**From:** Sebastian De Brennan  
**Sent:** 13/08/2023 10:30:44 PM  
**To:** Council Northernbeaches Mailbox  
**Subject:** REV2023/0016: RE DEVELOPMENT APPLICATION DA2022/2270 AT 166 PITTWATER ROAD MANLY NSW 2095  
**Attachments:** Submission re extension re 166 Pittwater Rd Manly NSW 2095.pdf;

**DEVELOPMENT APPLICATION DA2022/2270 AT 166 PITTWATER ROAD MANLY NSW 2095**

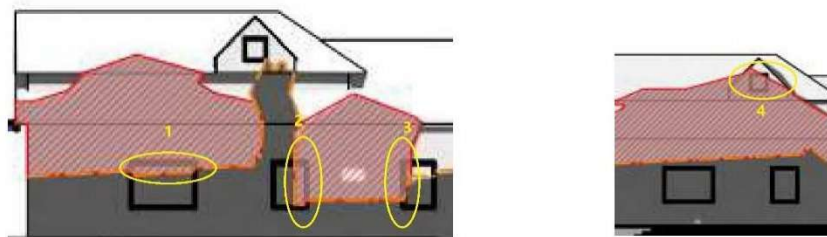
7. These two shadow diagrams are used to simulate the solar access between noon and 3:00 pm in mid-winter.<sup>3</sup> The concern is that the solar access of the adjoining property, as marked on the diagrams above, could be significantly compromised. Further, such a design is potentially at odds with the DCP which seeks to promote equitable access to light and sunshine.<sup>4</sup>
8. Although the Report contends that the proposed development will not create any significant additional overshadowing to windows to the property,<sup>5</sup> it is submitted that overshadowing of even a minor kind is not something that the Council should allow. In *Archiworks Architects Pty Ltd v Marrickville Council* [2005] NSWLEC 164 (**Archiworks**), the Land and Environment Court found:

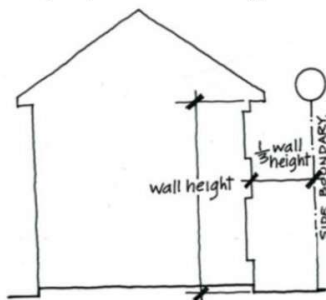
10. The development proposal intends to provide for roughly 6.59 m high wall on the common wall, thereby affecting our semi-detached house.<sup>7</sup> The immediate concerns associated with the erection of this structure is interference with amenity, as well as safety considerations.
